PLANNING, ZONING, & BUILDING DEPARTMENT
PZ&B Combination Staff Memorandum: Architectural Commission and Town Council

SUBJECT: ZON-23-041 (ARC-23-032) 176 SEMINOLE AVE (COMBO)

MEETING: JUNE 28, 2023 ARCOM
JULY 12, 2023 TC

Second Story Setback Reduction Diagrams

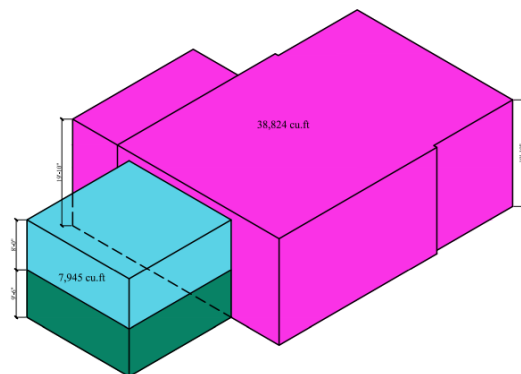
Variance #1 seeks a 1'-0" reduction of the required rear setback for the addition of the second floor. The rear setback amount for ground floors is 10'. The rear setback amount for second floors is 15'. The existing setback for the ground floor is 14'-0", and for ease of construction, the applicant is proposing to build up from the one-story portion, requiring rear setback reduction of 1'-0".

Staff notes that the setback relief would generally only impact the property to the south, which is commercially zoned. Staff is generally supportive of the variance due to the existing configuration of the property and the minimal impacts to surrounding properties.

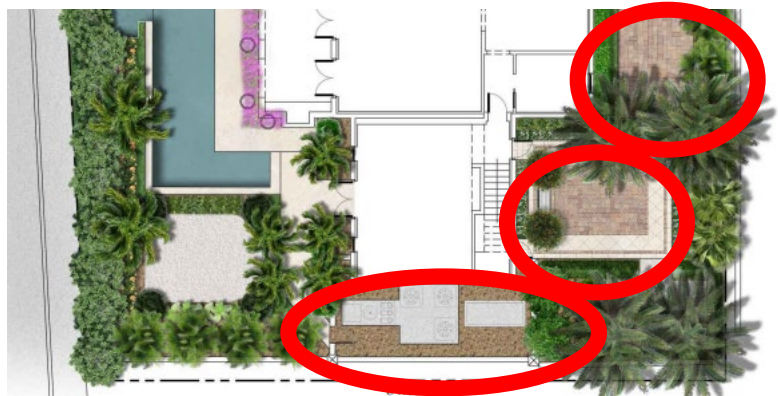
Variance #4 requests to reduce the required Landscape Open Space (LOS) to 37.8% in lieu of the 45% minimum required. Should the elimination of garage parking be approved, staff is largely supportive of the current request to modify the rear portion of the driveway due to the circumstances of the property's zoning history. Per the record plans, at the time of its construction, the property complied with the minimum Landscape Open Space requirements—which in 2003 was 40%. This was increased in 45% in 2005, pursuant to Ord. 01-05.

The applicant has made considerable efforts to bring the subject property more into compliance through the current application. The existing condition is roughly 36%, or 3,647 SF of green space. The current application proposed to reduce the amount of paving at the garage vehicular access point, which increases the LOS amount by roughly 200 SF. However, at the June 28, 2023 ARCOM meeting the item was approved (4-3) with the following condition to increase the amount landscape in order to reduce variance—an actual threshold amount of increase was not established. Staff would recommend that the applicant revise the hardscape and landscape plan and bring the overall landscape open space up to at least 40% (4,079 SF) from the current proposal of 37.8% (3,847 SF). With the elimination of the garage component from the residential component, the amount of hardscape formerly accessing the driveway and garage backout should rationally be reduced.
